Change Request

Description: Police Facility: RFI 126 - Trench Drain Reinforcement

RFI

Subject: Police Facility: Rebar Detail At Trench Drains in Sally Port

FOUNDATION SECTIONS
S200

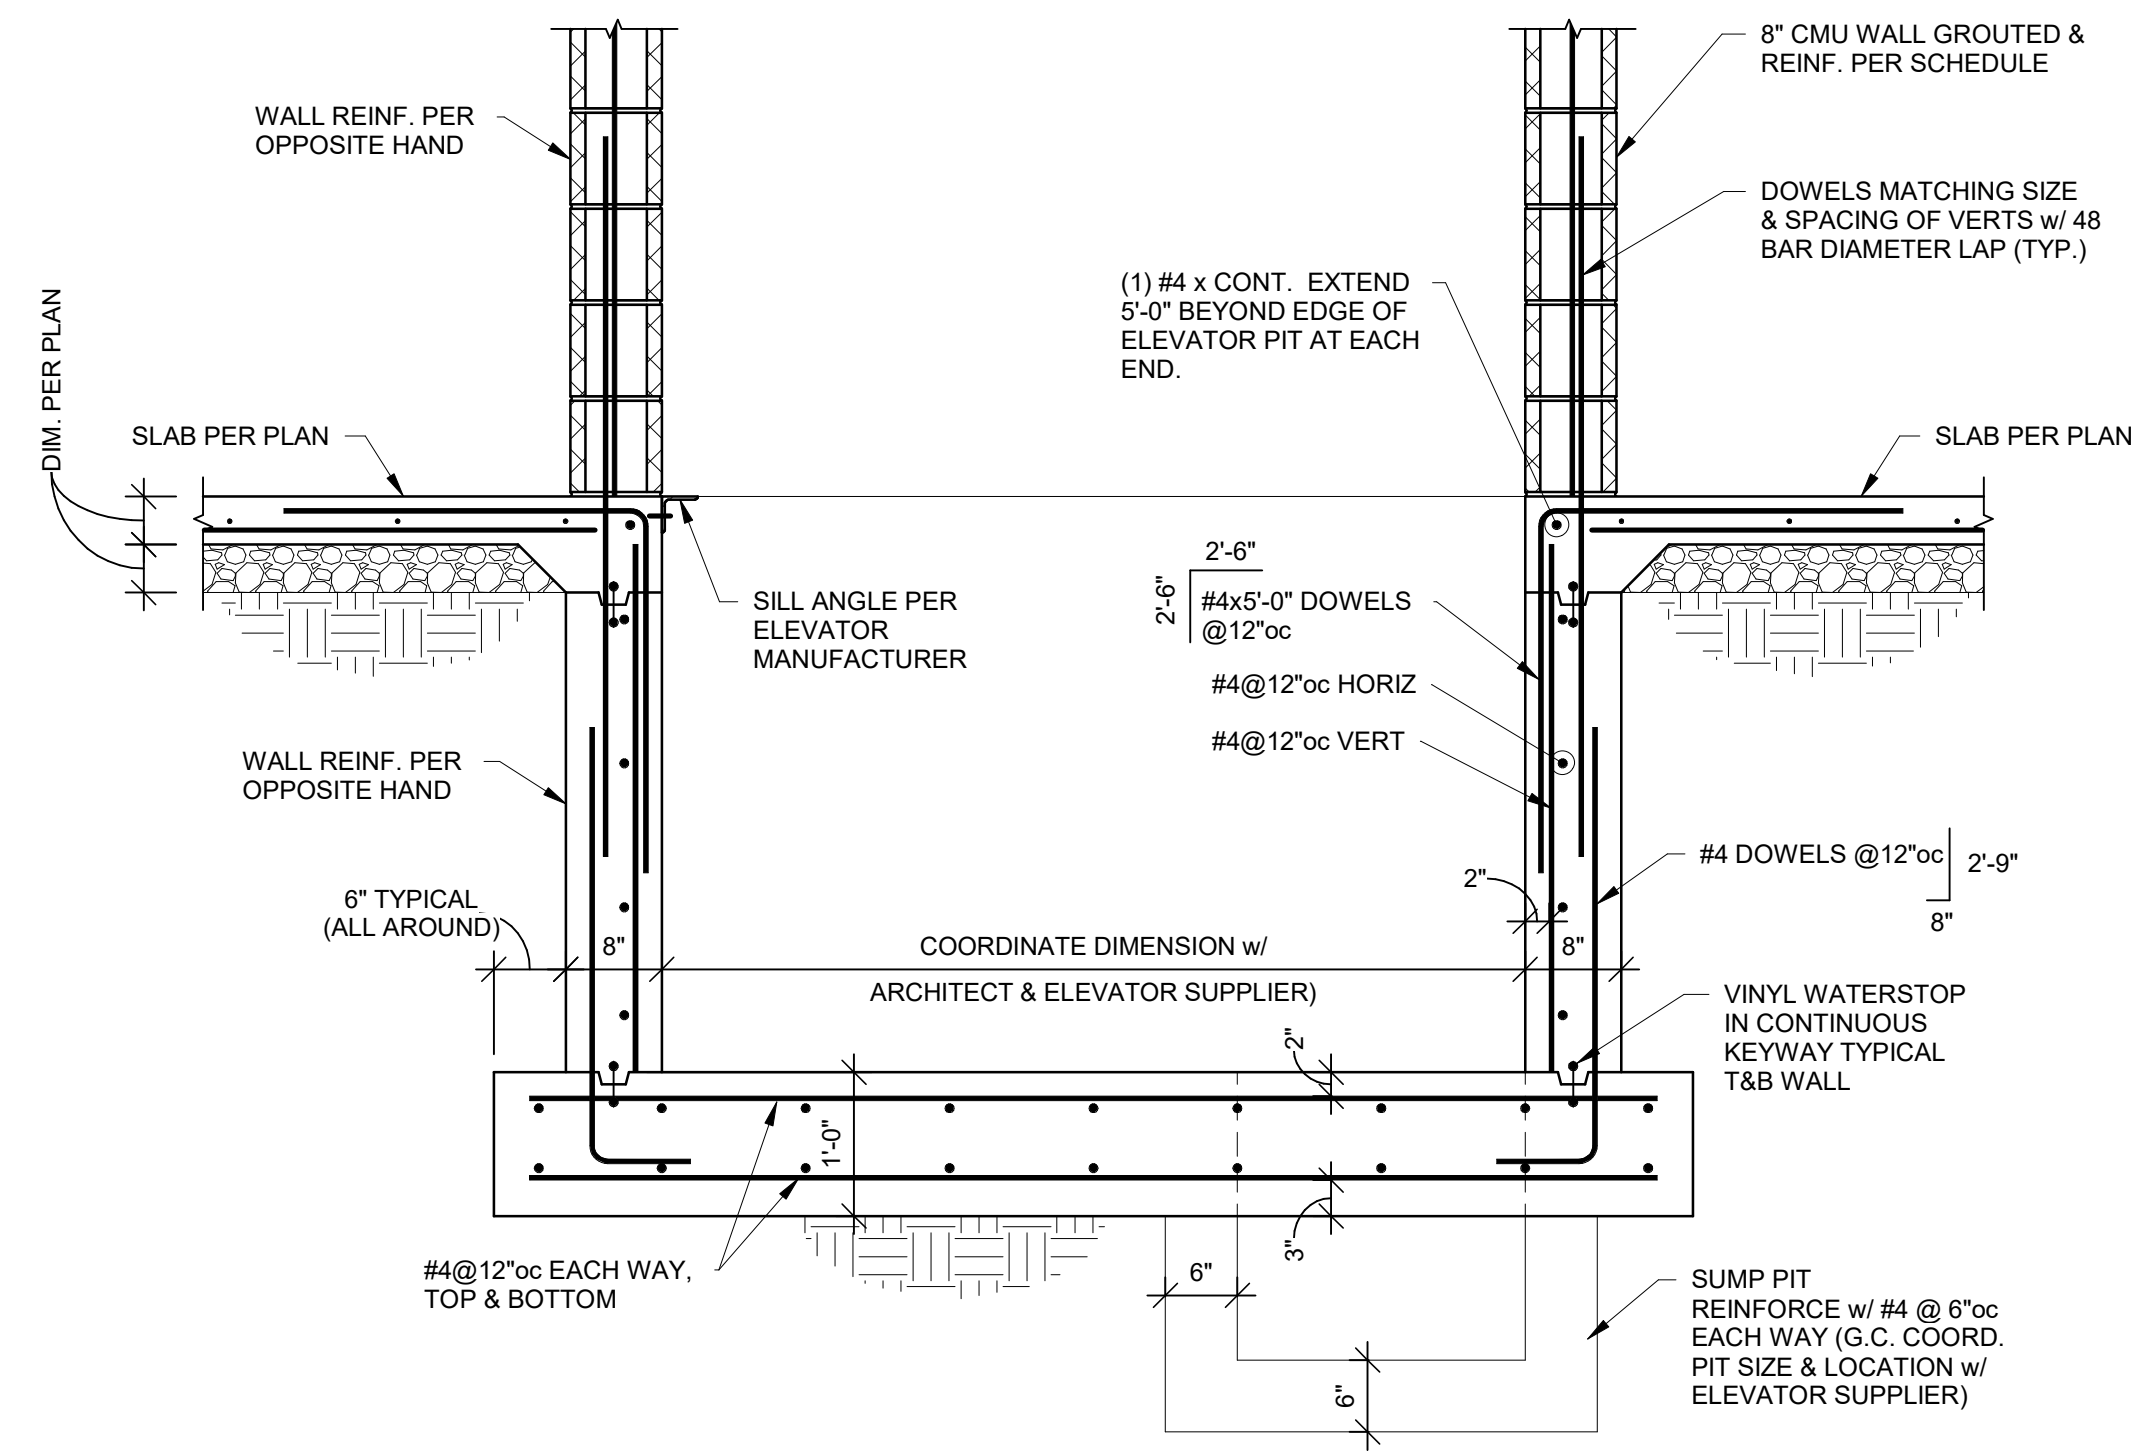
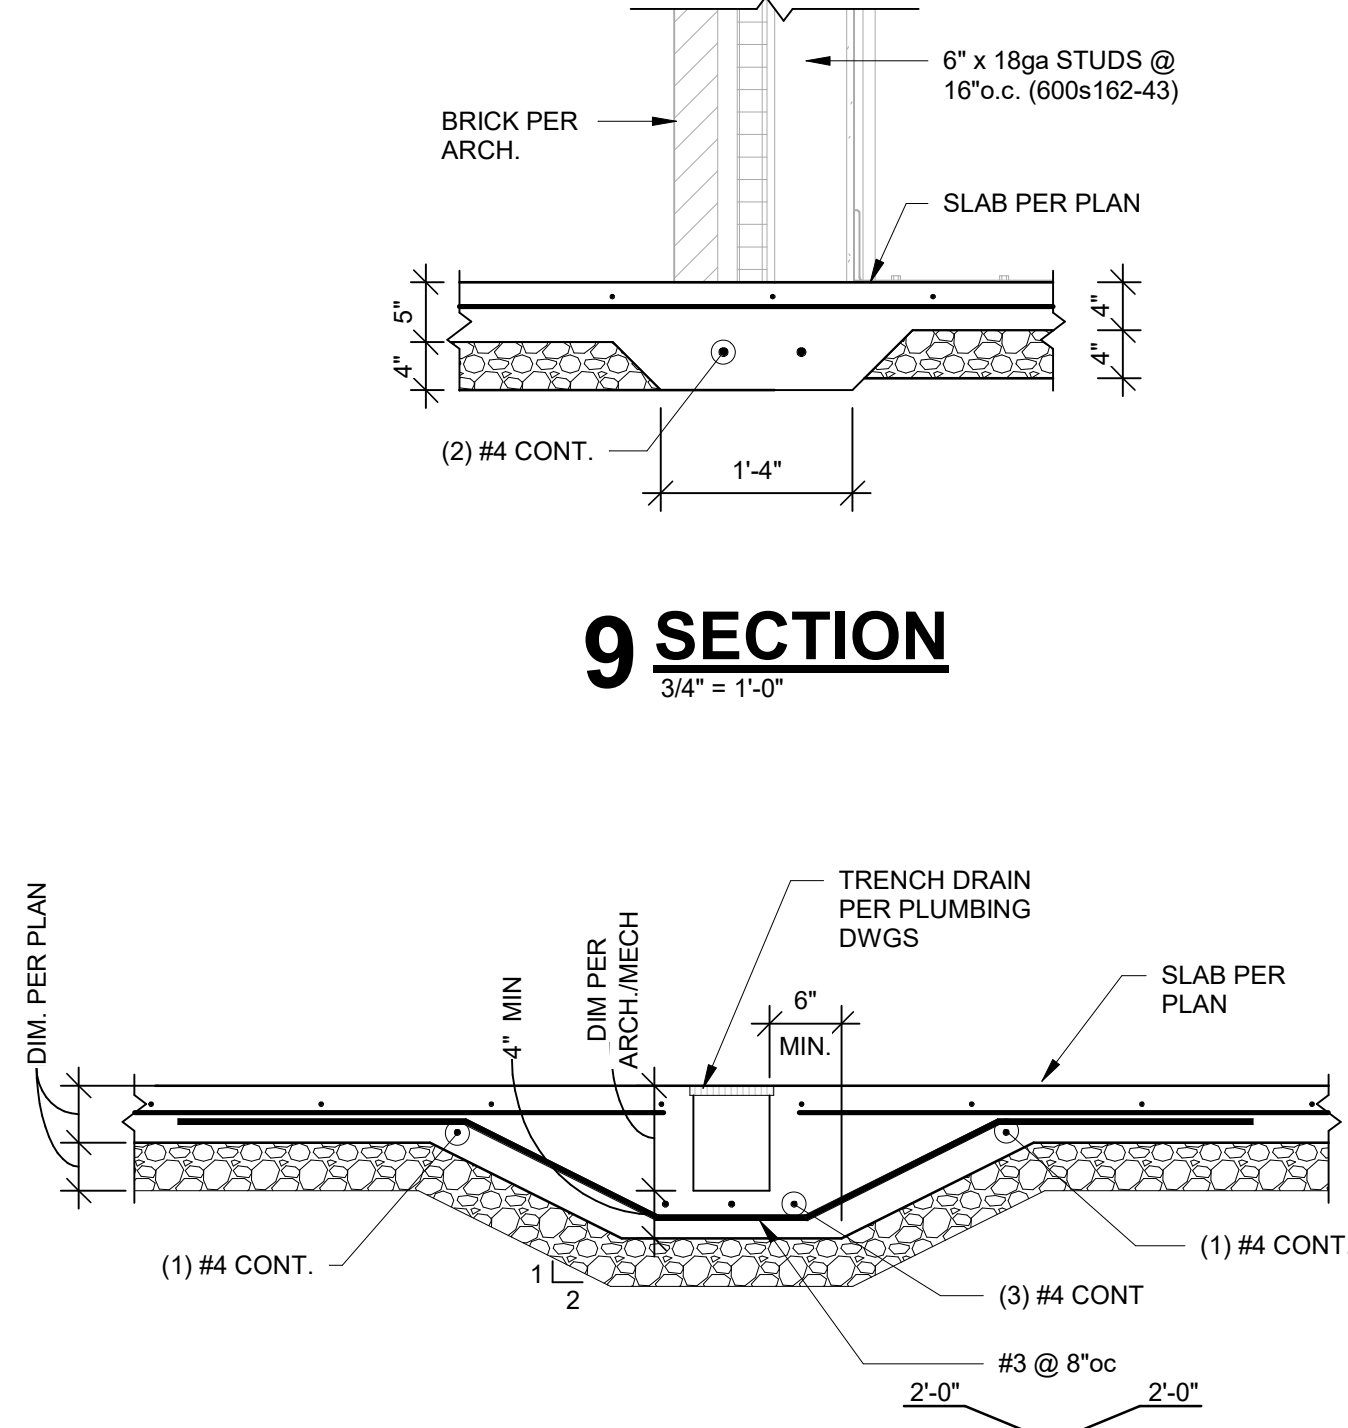
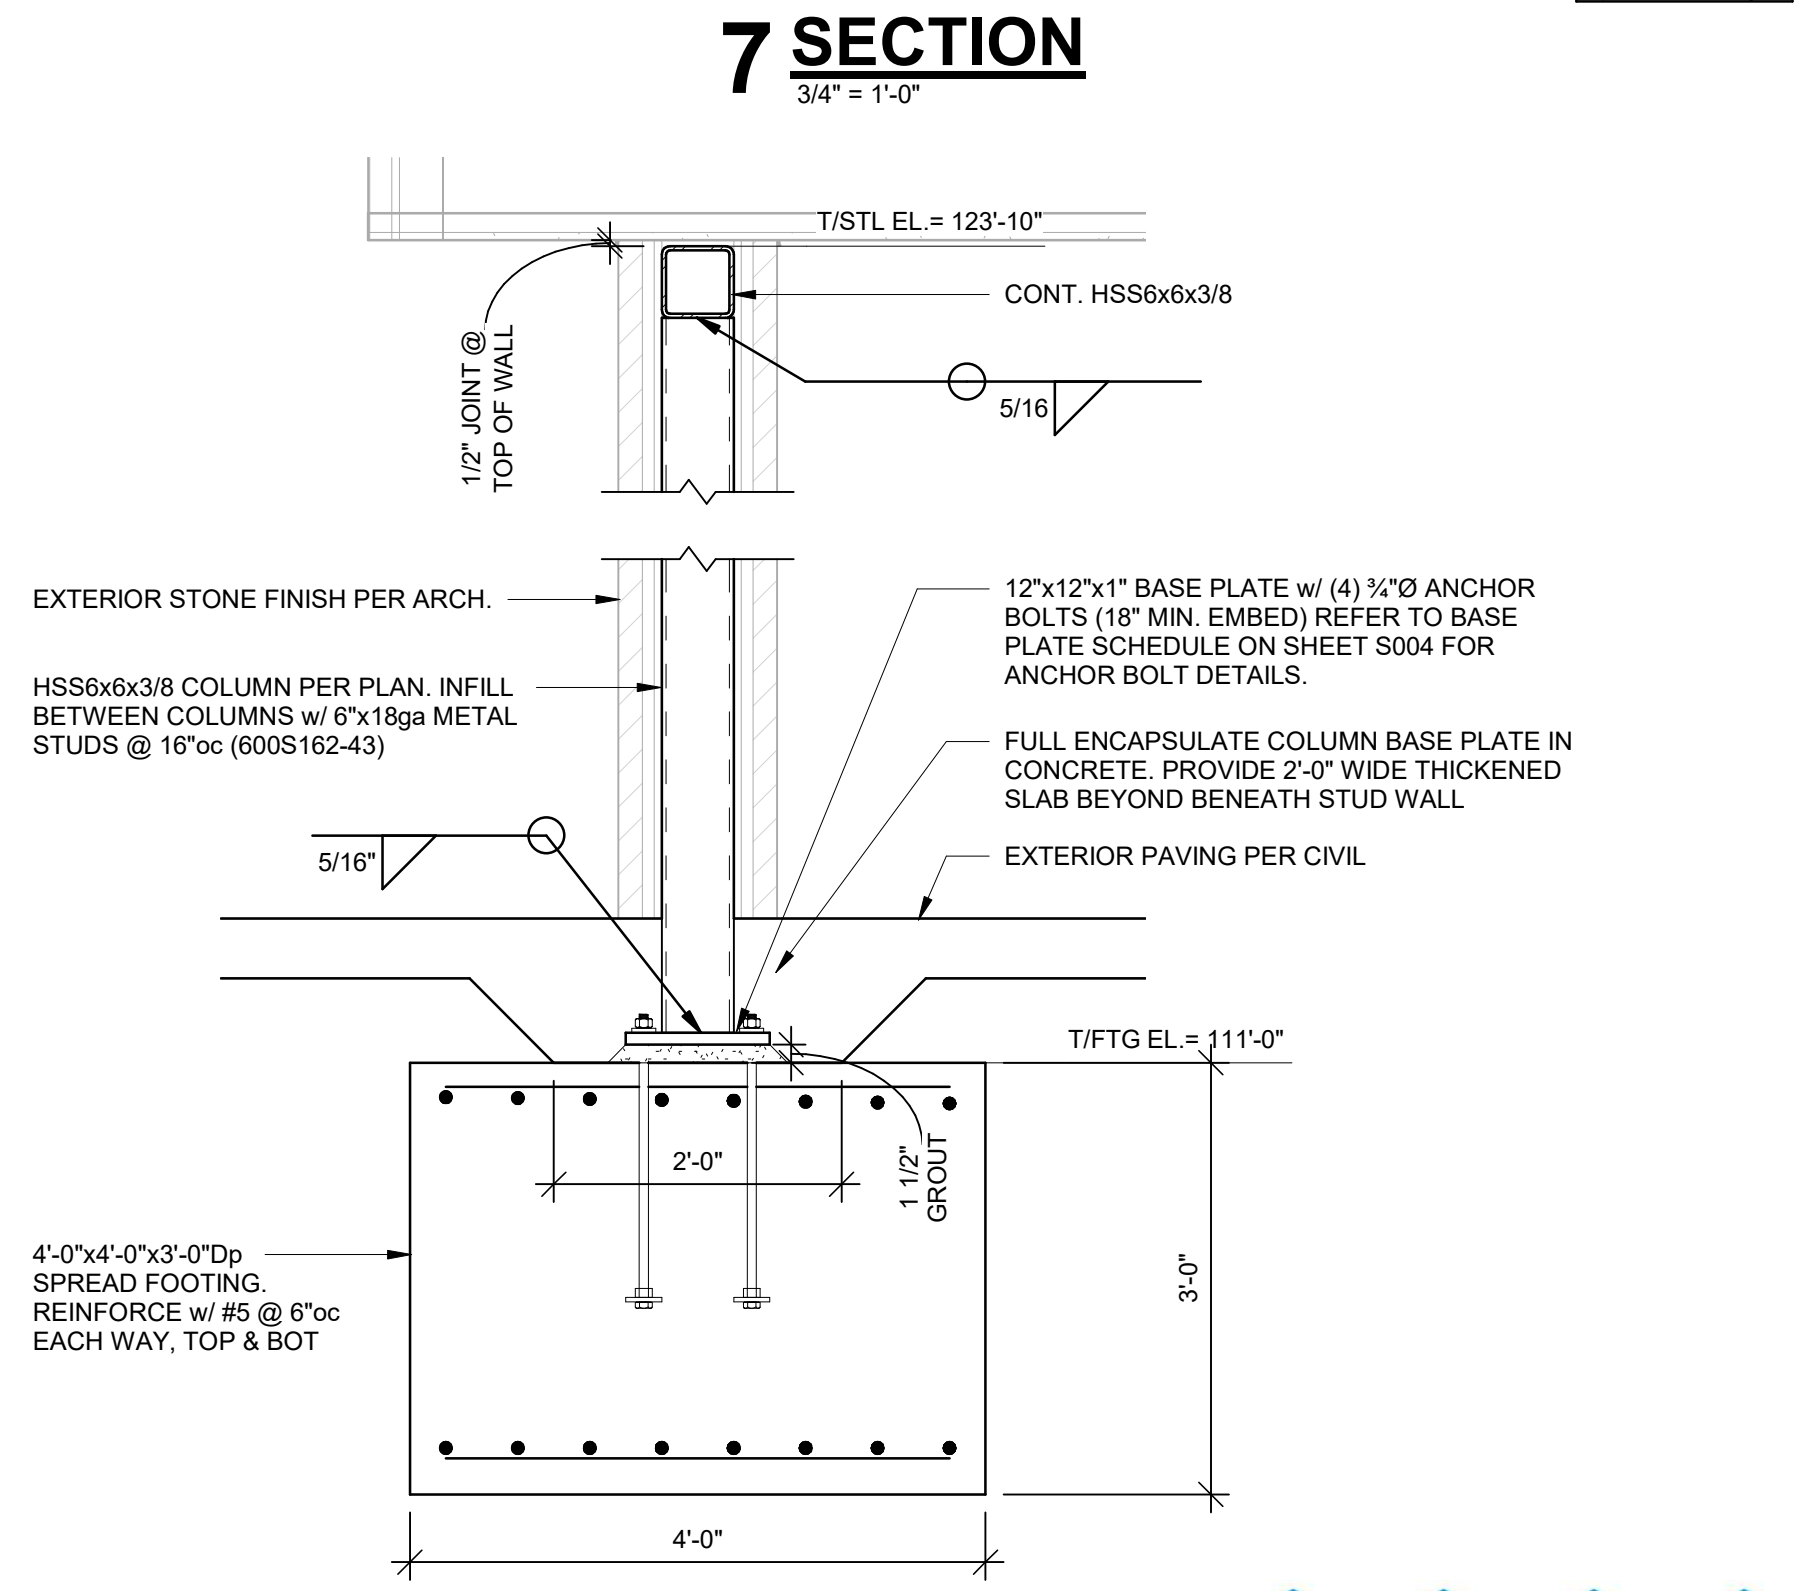
REV.	DATE	DESCRIPTION
1	12/8/19	RFI-114
2	12/8/19	RFI-126

Trench drain reinforcement per detail provided by Structural Engineer.

Supply and placement of concrete leveling pad for trench drain
Supply and placement of rebar around trench drain
Supply and placement of concrete around trench drain
